Subject: 10CFR21 Reporting of Defects and Non-Compliance -
Engine Systems, Inc. Report No. 10CFR21-0095, Rev. 0

Ingersoll-Rand Series 89 Air Start Motors, P/N 8367694-ESI

Report No. 10CFR21-0095

**10CFR21 REPORTING OF DEFECTS
AND NON-COMPLIANCE**

AIR START MOTOR CROSS-SECTION

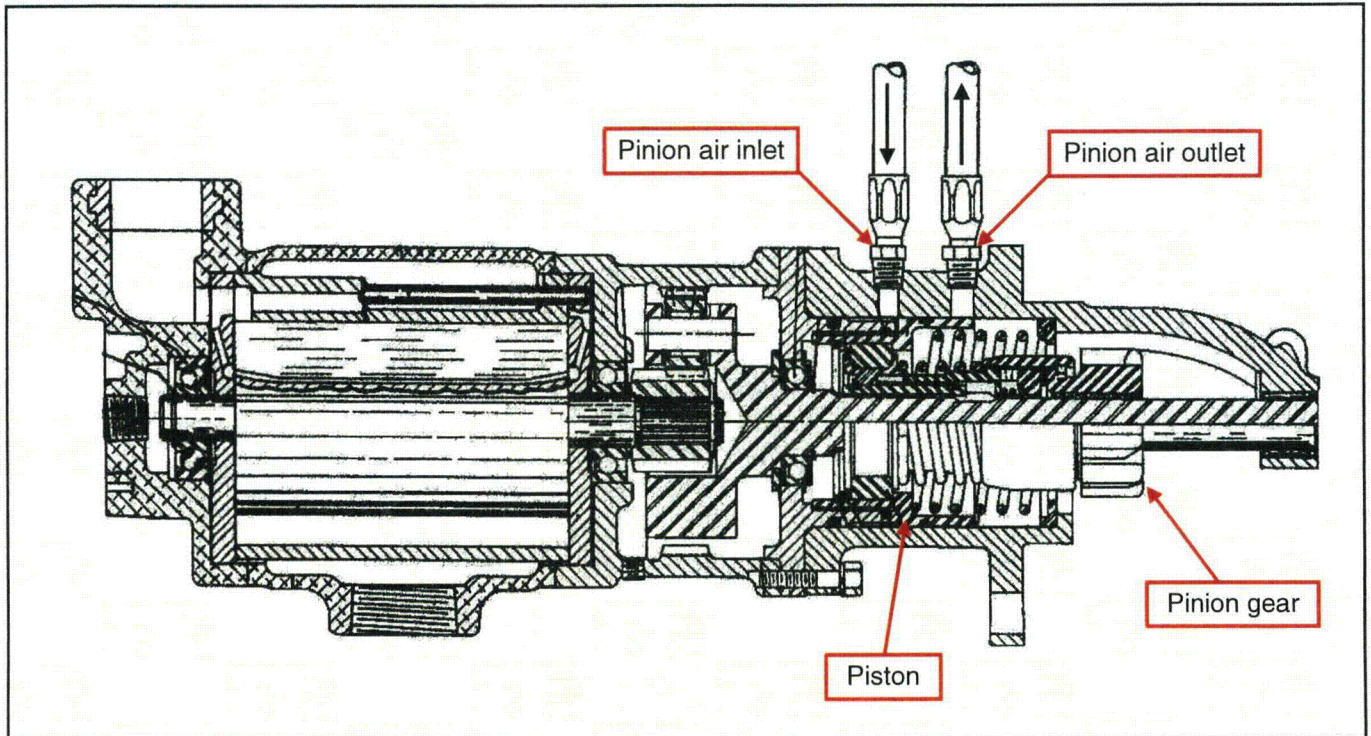
ESI inspection determined that Ingersoll-Rand used the wrong pinion engagement piston during assembly of the air motors. A new style piston with an elastomer seal ring (used in I-R's series 88 air starters) was incorrectly installed in the drive housing instead of the required piston with a metallic seal ring (required for the series 89 motor).

Series 88 Drive Pinion
INCORRECT

Series 89 Drive Pinion
CORRECT

Installation of the elastomer seal and piston within the series 89 starter could impact starting reliability of the diesel engine for the following reasons:

- (1) the elastomer seal is located further away from the drive gear on the piston; this requires increased travel of the piston to port air from the pinion outlet port. During abutment of the starter drive gear with the engine ring gear, air will not port from the starter to activate the main air start valve and thus engine cranking will not occur.
- (2) the elastomer seal can be cut by the pinion outlet port hole in the starter drive housing after a number of starter engagements. This could cause binding of the piston within the drive housing and or excessive air leakage past the seal. Both conditions could increase the time required for the pinion to engage with the engine flywheel and thus compromise the fast start capability of the engine.

INSPECTION PROCEDURE (OPTIONAL):

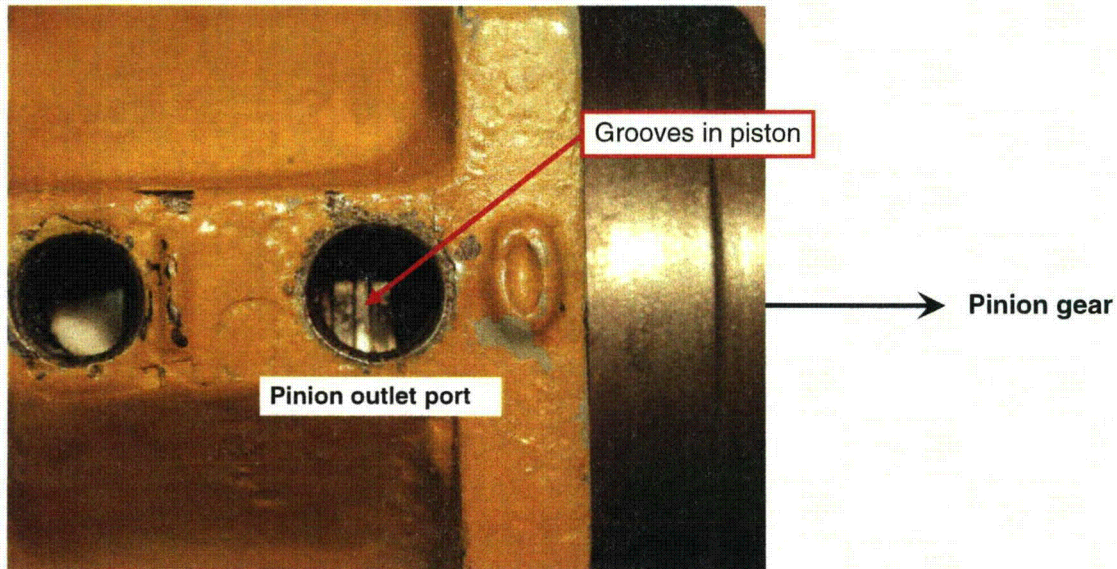
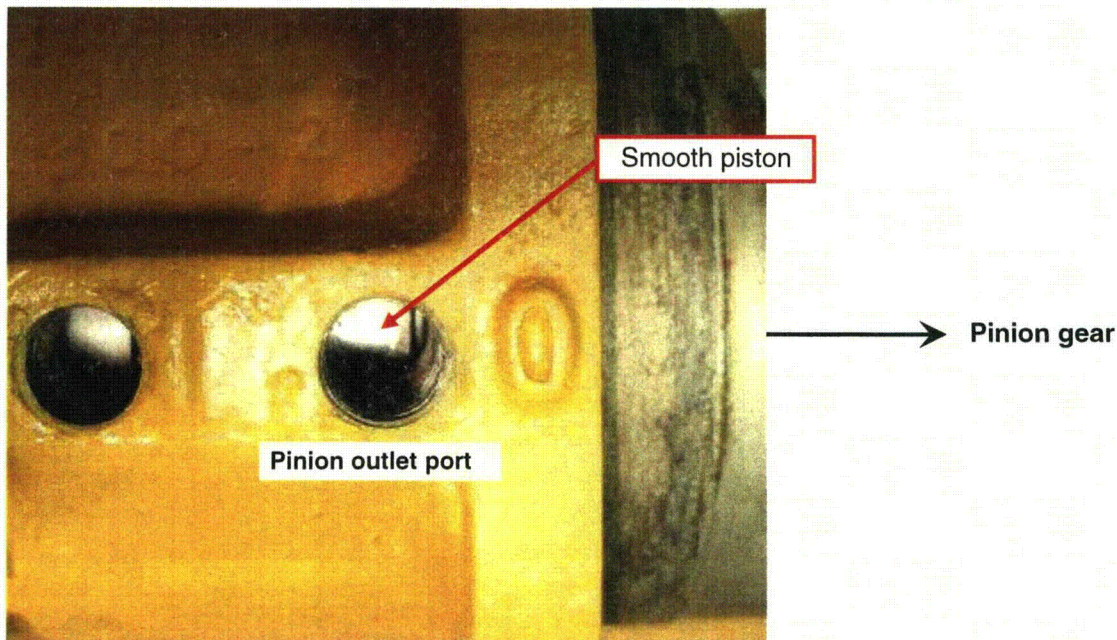
The pinion piston can be viewed through the pinion air outlet port to determine proper configuration. Refer to photos below.

INCORRECT

CORRECT

1. ESI has contacted all affected customers that were shipped the incorrectly assembled starters. All starters have been returned to ESI.
2. ESI has added verification of correct pinion piston and seal assembly to the critical characteristic inspection activity for future starter shipments.
3. If desired, users can inspect other starters in their inventory to verify correct assembly of the pinion piston and seal. An inspection procedure is provided on the following page.
